KTN WOLFE POINT SLOPE STABILITY IMPROVEMENTS

PROJECT NO. 0920(032)/SFHWY00432

GRADING AND SIDE SLOPE STABILIZATION

Record Drawings have been reviewed by the Project Engineer, and represent to the best of my knowledge, the project as constructed.

EROSION SEDIMENT CONTROL PLAN

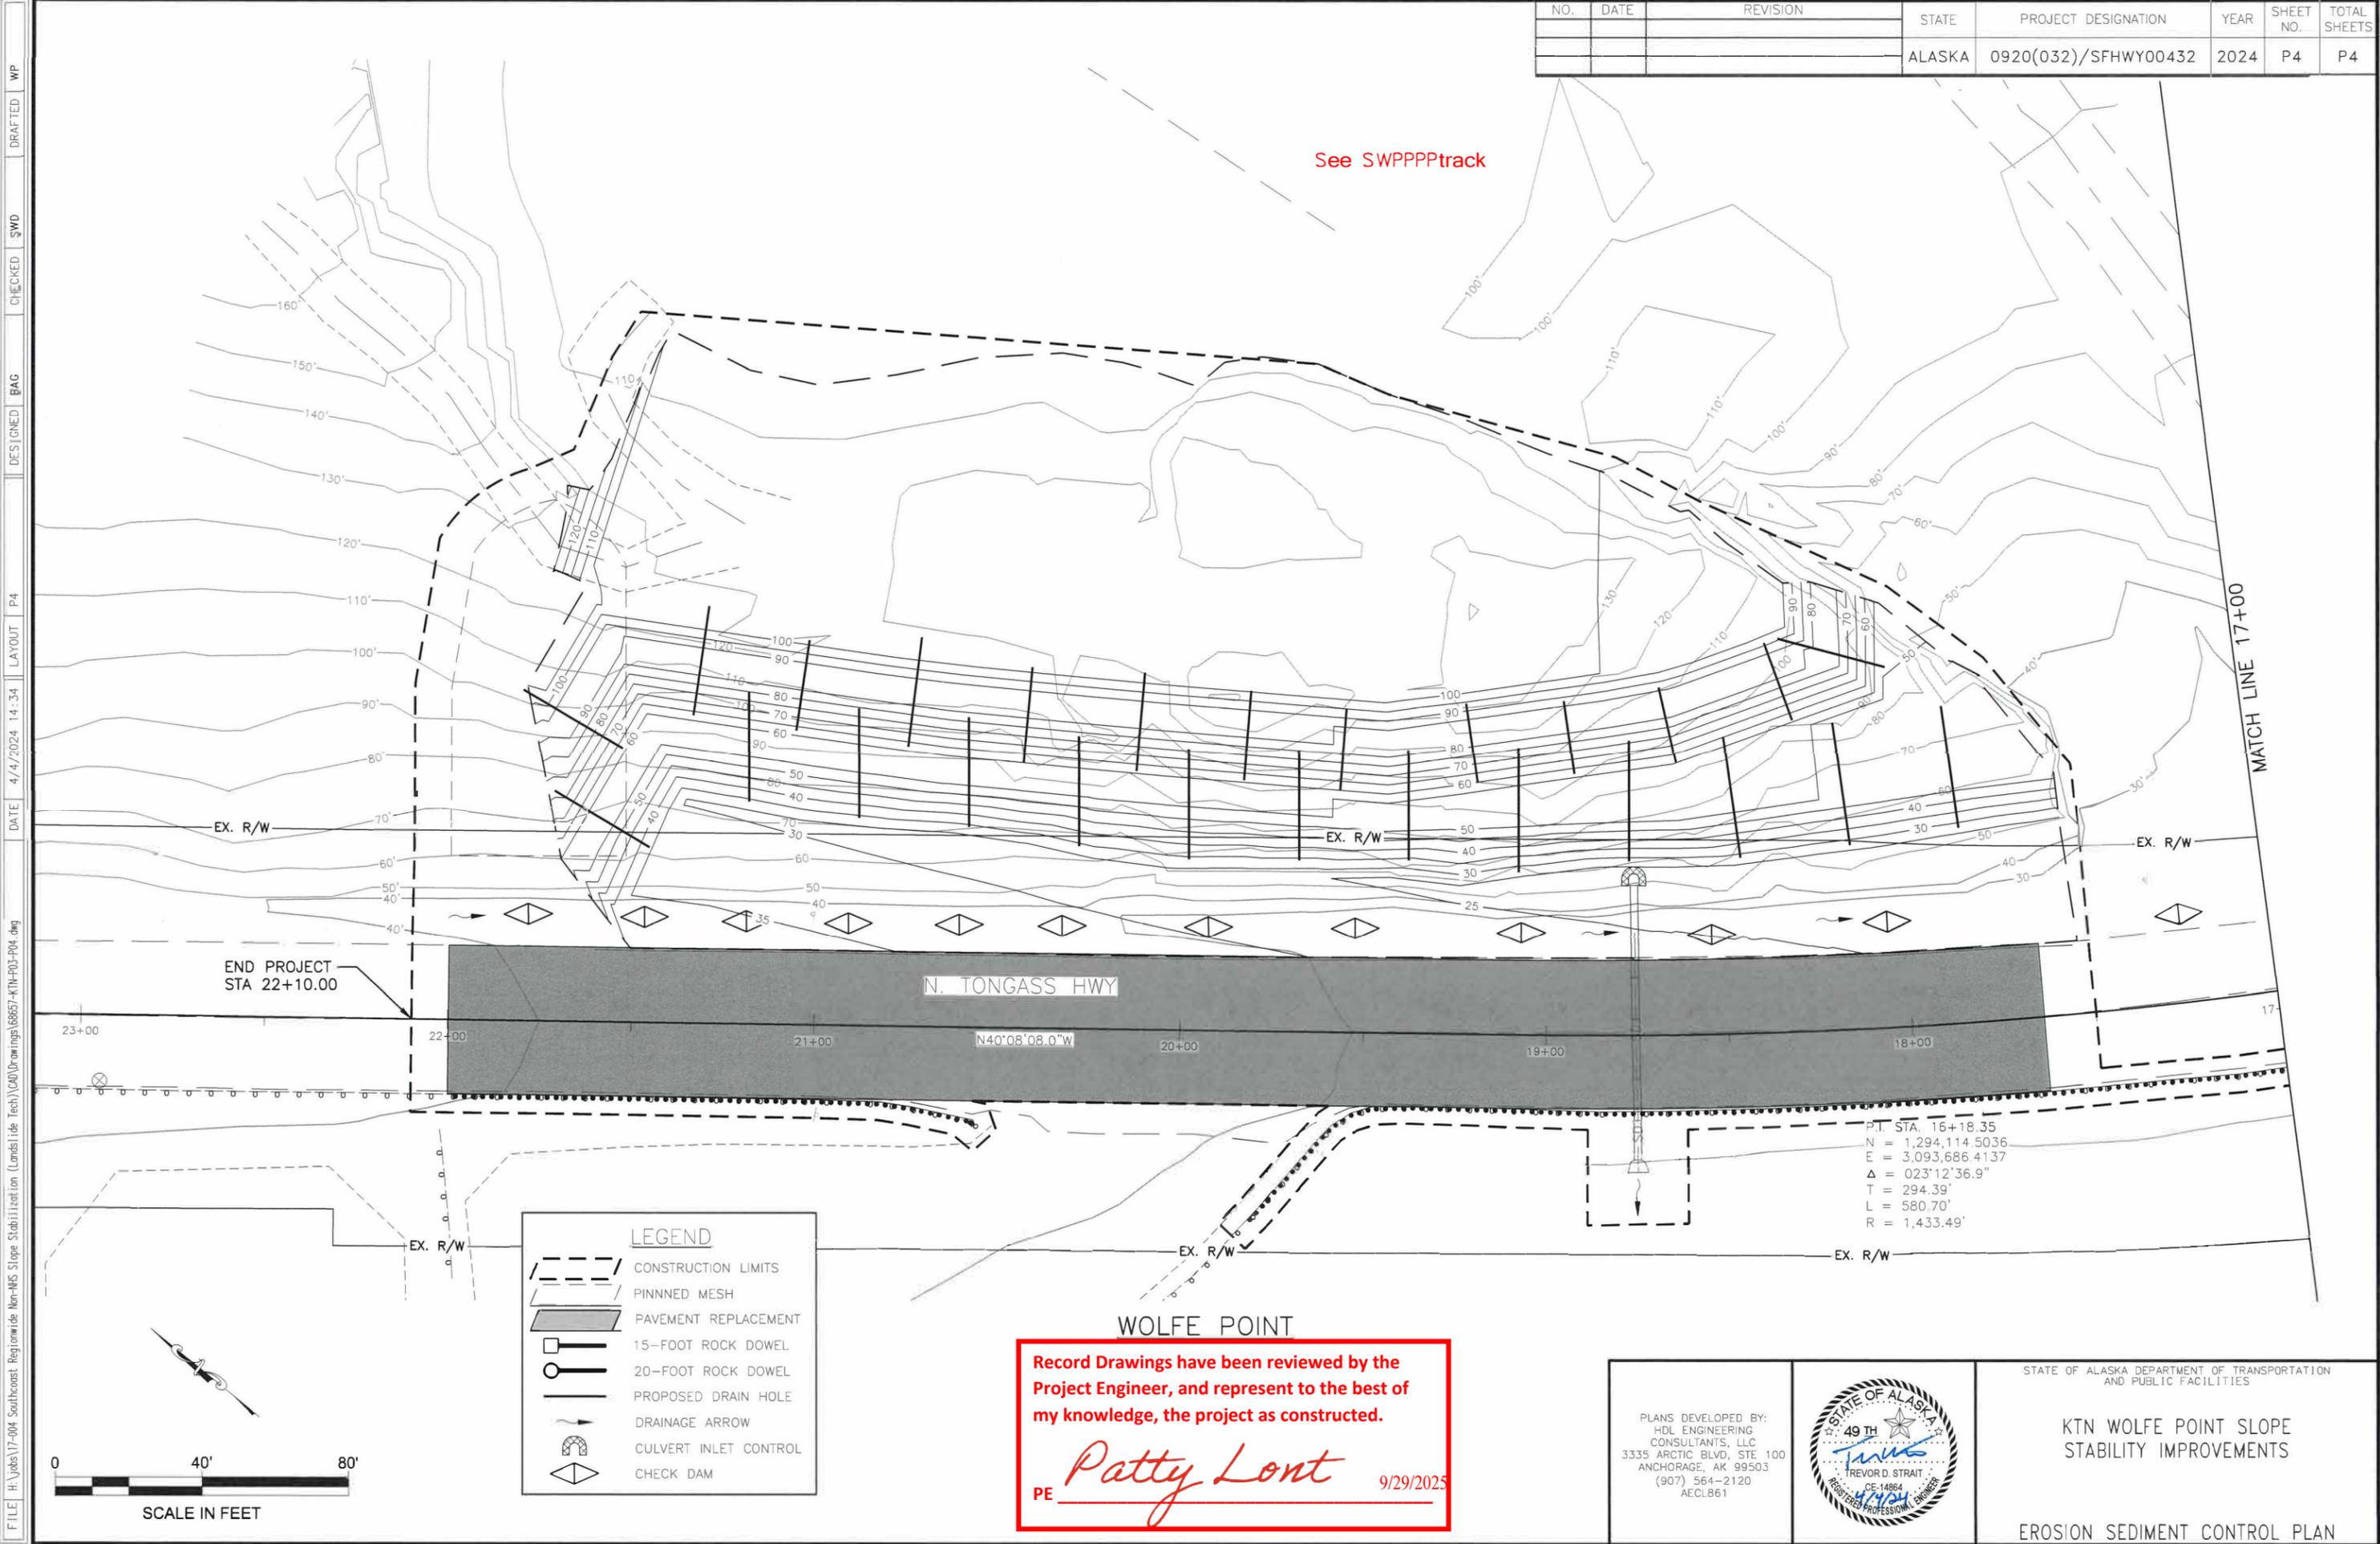
See SWPPP track
